## MEMORANDUM

<b>DATE:</b>	March 10, 2021	<b>RWDI REFERENCE #:</b> 1904405
<b>TO:</b>	Anthony Witherdin	Director, Key Sites Assessments - DPIE
<b>FROM:</b>	Kevin Peddie	<b>Email:</b> kevin.peddie@rwdi.com
	Michael Pieterse	michael.pieterse@rwdi.com
<b>RE:</b>	<b>Wind Environment Conditions – City of Sydney Review Response Waterloo Metro Quarter – Building 2, Communal Open Space</b>

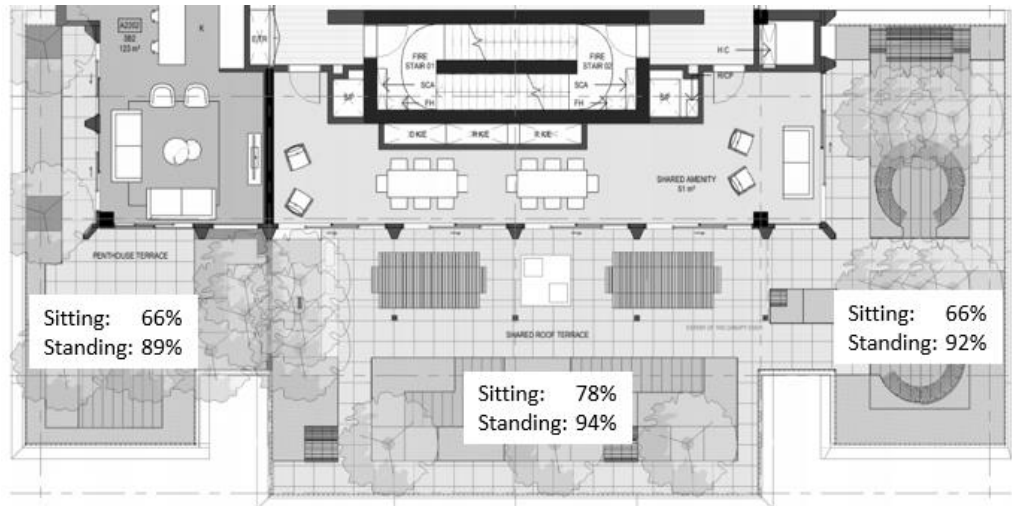
*Communal open space - Communal outdoor space is underprovided at 186sqm on level 22. According to the application, this equates to 7.5% of the site area, in contrast to the minimum 25% minimum recommended under Objective 3D-1 of the ADG. The wind analysis concludes that the terrace only achieves 'walking' comfort criteria in summer, and 'standing' conditions for the winter period. Neither is acceptable – the communal open space should be suitable for 'sitting' activities.*

**Wind Comfort Conditions for the Level 22 Communal Space**

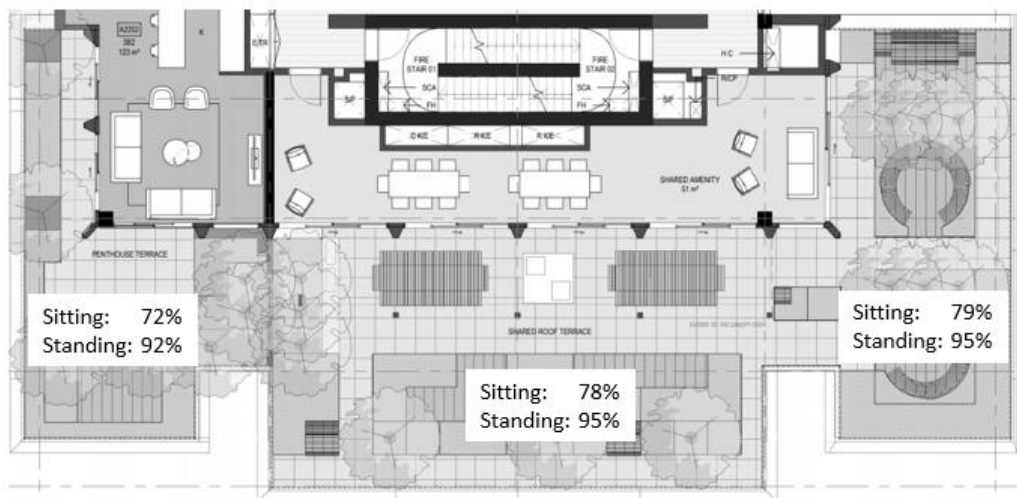
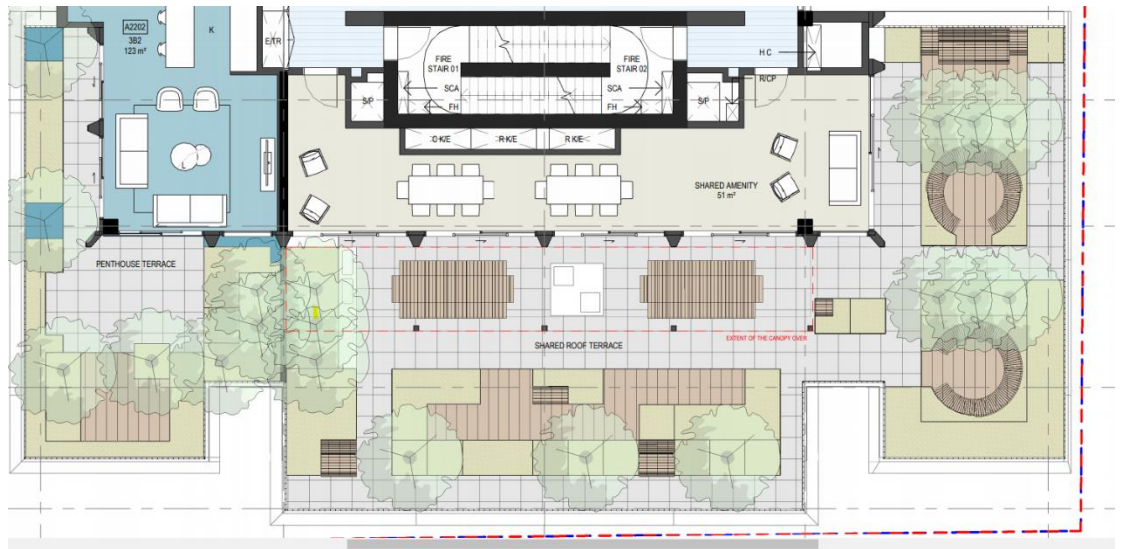
Comment is noted from the City of Sydney that this area will experience walking comfort conditions in the summer months and standing during the winter months. It is worthwhile noting that the entire rooftop area will satisfy the standing criteria during the summer months for at least 89% of the time. Sitting conditions will be satisfied for at least 66% of the time during the summer months and at least 72% of the time during the winter months. The below figure provides a breakdown of the percentage of the time that the sitting and standing criteria will be achieved for the communal open space, which is extracted from the detailed wind tunnel study report.

Modelling undertaken and noted in the above figure included only the balustrade and pergola structure noted in the architectural drawings, without any consideration of the landscape design. The following figure shows the proposed landscape design of the communal space, which includes notable landscaping at the northern and southern areas. These will be beneficial in assisting to buffet the local wind effects, improving the percentage of time that sitting conditions are provided for residents using this space.
